**CITY OF MADISON  
INTERDEPARTMENTAL  
CORRESPONDENCE**

**To: Plan Commission**  
**From: Matt Tucker, Zoning Administrator**  
**Subject: 5110 High Crossing Blvd.**

**Proposed Use: Planned multi-use site including four-story, 106 room hotel and two-story health club.**

TITLE: 5110 High Crossing Boulevard – Planned Multi-Use Site for a Four-Story, 106-Unit “Holiday Inn Express Hotel” and a Two-Story, 44,000 Square Foot “Gold’s Gym” Health Club. 17<sup>th</sup> Ald. Dist. (37163)

REQUESTED EASEMENTS - ALLIANT ENERGY

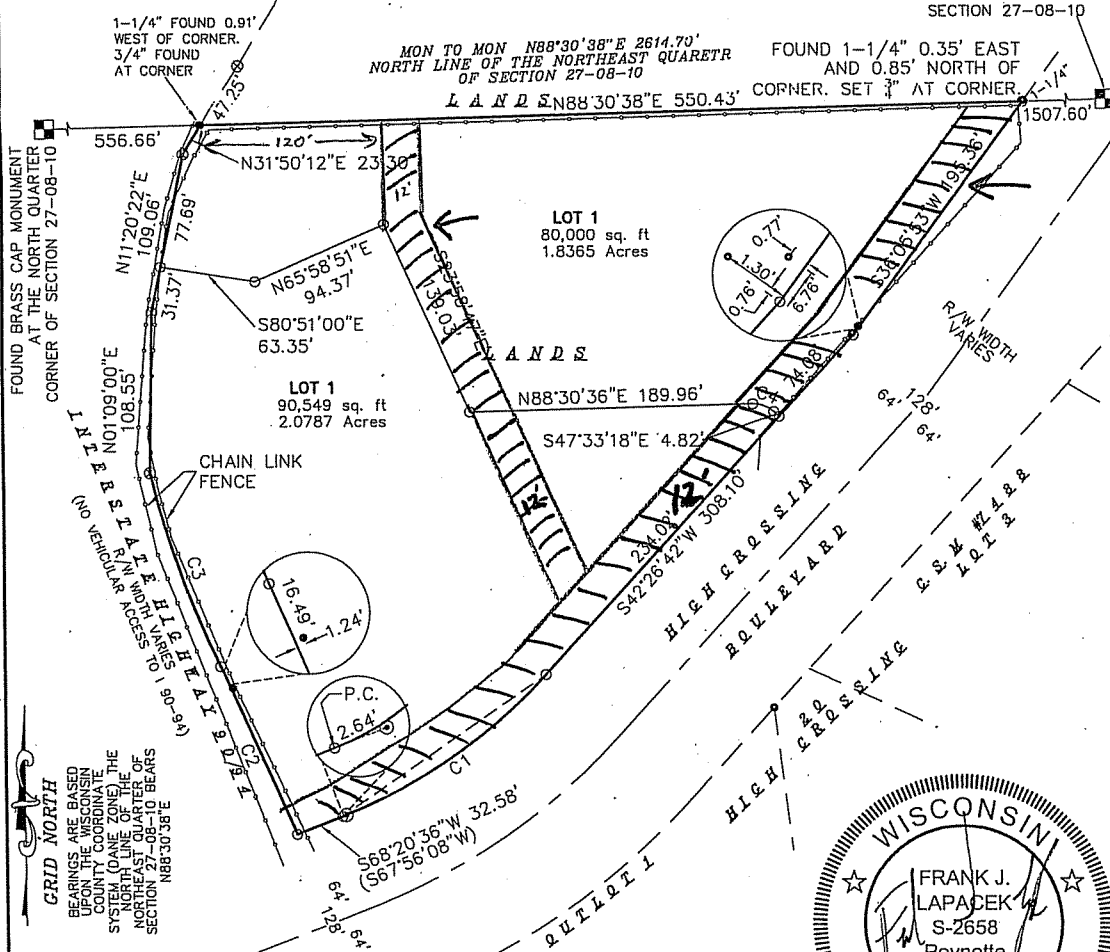
*Please see attached for requested easements.*
